Project Comment Form

CRS# 61065338

Fieldstone Messenger House Memory Care
Chapter 388-78A WAC Assisted Living Facility

Project Title: Convert NH To ALF

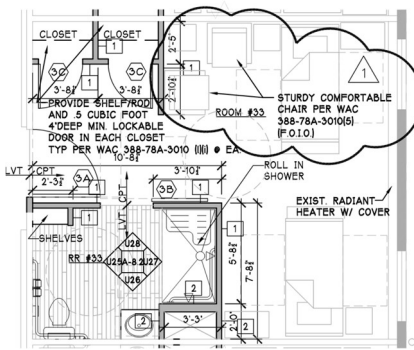
6	<input checked="" type="checkbox"/>		<p>The functional program must inform the design process. WAC 388-78A-2361 (1)</p> <ul style="list-style-type: none"> a) The functional program identifies a Living room / Great Room with space for socializing and a fireplace. Furnishings consist of chairs, couches, end tables, bookcases and wall hangings. b) A passage in the FP under 'Fireplace and Emergency Heat' states, there are no fireplaces in the memory care portion of this site. A fireplace is shown in Sitting area #400 and on sheet A6.1 detail 12. <ul style="list-style-type: none"> • Coordinate the plans and FP to align more closely.

<ul style="list-style-type: none"> Identify, on the plan, the location of this room (Great Room / Living room) where residents may independently sit and socialize without staff escorting them. <p><i>Response 05.18.2020 – Please review the updated FP showing correct information as related to the plans and how the spaces will be utilized and activities will be performed. Areas designed for socialization are not restricted to requiring residents to be escorted to and from these places.</i></p> <p>Approved 05.29.2020 – based on the response above and the revised functional program.</p>
7	<input checked="" type="checkbox"/>	<p>The assisted living facility must provide space and support necessary for each resident to engage in independent or self-directed activities. WAC 388-78A-2180(1)(a)</p> <p>The current design only allows access to the Townsquare when the resident is escorted. No Living room or activity common space is provided on each wing other than the circulation (corridor) path. The 9 foot corridor between units is not considered a gathering or socializing space. Past designs have included a large social gathering space (20+ feet wide) on each wing for residents to gather and socialize. This design does not provide the common space for a ‘homelike’ design for residents. This space must be independent of staff /family escort. See comment 8 below for common area requirements.</p> <p>Below are additional concerns with the proposed design:</p> <p>a) Doors 20 & 30 are identified as controlled egress doors. This cuts off the Dining and activity space from all residents unless they are escorted. <i>Response 05.18.2020 – Doors 20 & 30 are egress doors that will be open unless the fire alarm is tripped as these doors are on Magnetic hold opens tied to the fire alarm as stated on the door schedule on Sheet A-2.9 “LEVER HANDLE W/PANIC BAR HARDWARE/MAG HOLD OPEN TIED TO FIRE ALARM FOR RELEASE, SMOKE BASKET, PROTECTED EXIT (SEE NOTE #11)”</i></p> <p>Not Approved 05.29.2020 – Doors schedule, sheet A2.9 identifies these doors with Note 11 for controlled egress. These doors are not allowed to be controlled so residents can have access without staff escort (as indicated in the FP). Residents must have access to common areas at all times. The doors can be on Mag Hold opens and released if there is a fire event and as an Occupancy/Smoke Barrier door. Removed the controlled egress portion of these doors.</p> <p>b) Doors 24 & 25 at the Townsquare exit to the courtyard are open at all times. Will residents be allowed to enter this space from the outdoor area? <i>Response 05.18.2020 – Yes, residents will be allowed to access the courtyard via door 24 & 25, the residents can go in and out through these doors. At the facilities designated night routine these doors will be secured to keep residents safe. There is also a call station at these doors (refer to Note N-1.0) should there be any reason for a person needing assistance.</i></p> <p>Approved 05.29.2020 – Residents are allowed to go in and out through these doors.</p> <p><u>RECOMMEND</u> discussing the locking of the doors at night with the RCS Field Manager. Per WAC 388-78A-2381(2)(d) residents must be able to access the outdoor area with minimal assistance except in times of inclement weather, dangerous construction or maintenance activities or other temporary environment factors create an unsafe environment.</p>
